MEMO

Subject: Review of Water Right Application G-19012

Groundwater Application Review Summary Form

Application # G- <u>19012</u>
GW Reviewer <u>Jen Woody</u> Date Review Completed: <u>9/11/2020</u>
Summary of GW Availability and Injury Review:
Summary of GW Availability and mjury neview.
Groundwater for the proposed use is either over appropriated, will not likely be available in the amounts requested without injury to prior water rights, OR will not likely be available within the capacity of the groundwater resource per Section B of the attached review form.
Summary of Potential for Substantial Interference Review:
\square There is the potential for substantial interference per Section C of the attached review form.
Summary of Well Construction Assessment:
☐ The well does not appear to meet current well construction standards per Section D of the attached review form. Route through Well Construction and Compliance Section.
This is only a summary. Documentation is attached and should be read thoroughly to understand the basis for determinations and for conditions that may be necessary for a permit (if one is issued).

Figure 2. Well Location Map

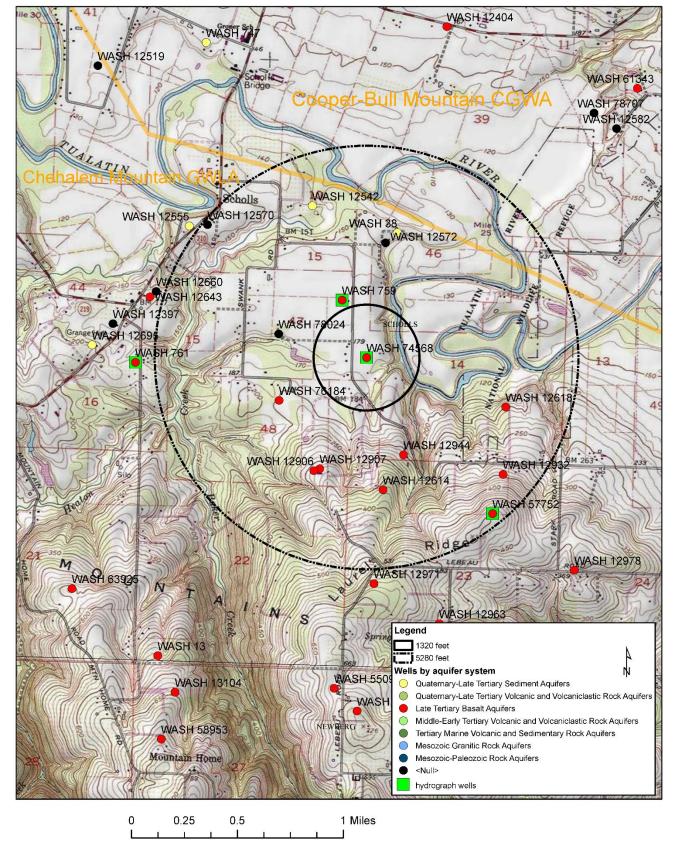
Criti basa	subject well is located in the alluvial plain of the Tualatin River, near the shared boundaries of Cooper-Bull Mountain cal Groundwater Area (CGWA) and the Chehelam Mountain Groundwater Limited Area (GWLA). The well is within a lt aquifer affected by the Chehalem GWLA. Wells in both groundwater administrative areas are sensitive to overdraft, nearby water level data indicate relative stability within the Chehalem GWLA (see Figure 3).										
		well is within the Chehalem Mountain Groundwater Limited Area. If a permit is issued, conditioning per Section A6 is ired.

Basis for aquifer hydraulic connection evaluation: The well is located less than ¼ mile from the Tualatin River, but the groundwater level is significantly different from the river. There is no effective hydraulic connection between the basalt aquifer that supplies the well and the local stream network, because of the low vertical permeability of basalt flow interiors and the overlying fine-grained sediments.
